APPLICATION OF AGAVE ENERGY  
COMPANY FOR AUTHORITY TO  
INJECT ACID GAS AND CARBON  
DIOXIDE, LEA COUNTY, NEW MEXICO

**AGAVE ENERGY COMPANY'S  
MODIFICATIONS TO ITS APPLICATION**

Agave Energy Company ("Agave") submitted its application for authorization to inject carbon dioxide and acid gas into its proposed Red Hills AGI #1 well on July 20, 2011. Subsequently, Agave determined that it would be beneficial from an operational standpoint to modify certain elements of its design of the proposed well.

**AGAVE RED HILLS AGI #1  
PROPOSED WELLBORE**

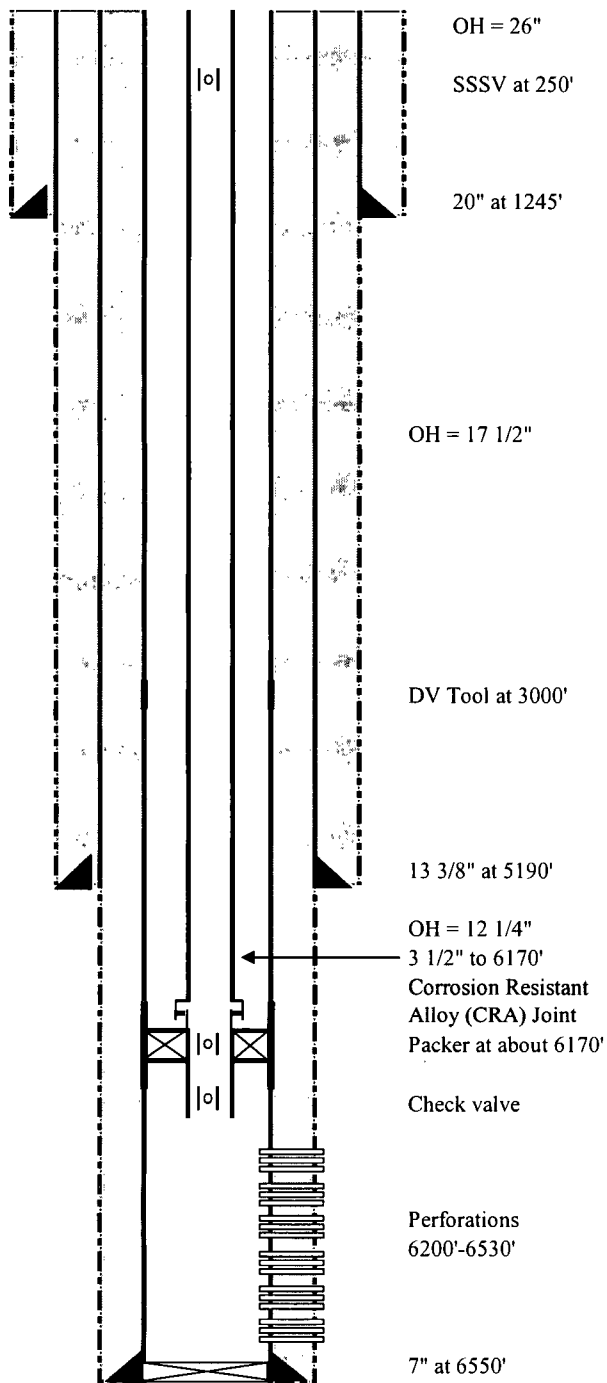
Copies of Agave's changes to the text of Section 3.2, proposed wellbore diagram, and Figures 4a and 4b in its application are attached hereto. All of the changes to the original application are highlighted.

20", 94#/ft, H40, STC at top of Rustler ~ 1245'

13 3/8", 54.5#/ft, J55, STC at base of salt ~ 5190'

7", 26 #/ft, L80, FJ at 6550'

Figure 4b: Schematic for Proposed Agave Red Hills AGI #1 Well Modified August 2011 to Ensure Sufficient Space for 7" Production Casing. Modifications are Highlighted

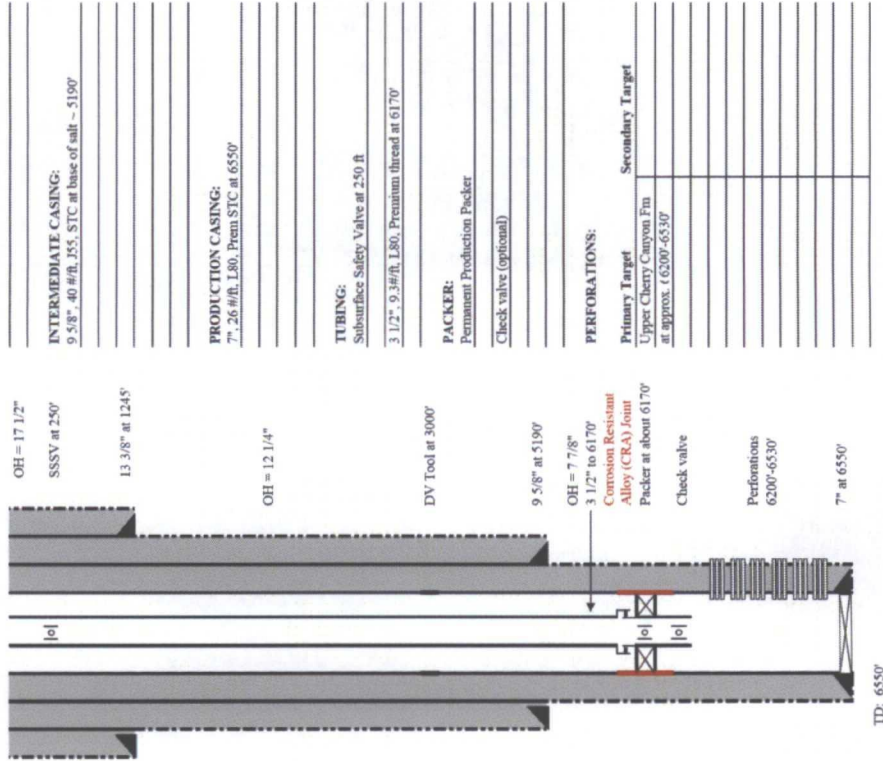
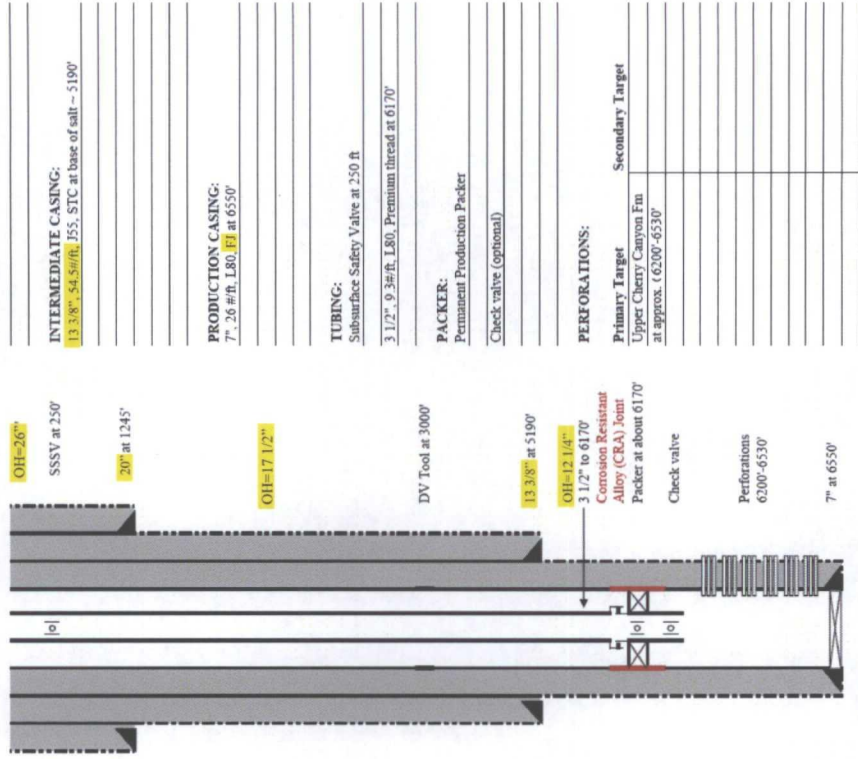
Figure 4a: Schematic for Proposed Agave Red Hills AGI #1 Well Included with C-108

**SURFACE CASING**  
20" 94#/ft. H40, STC at top of Rustler ~ 1245'
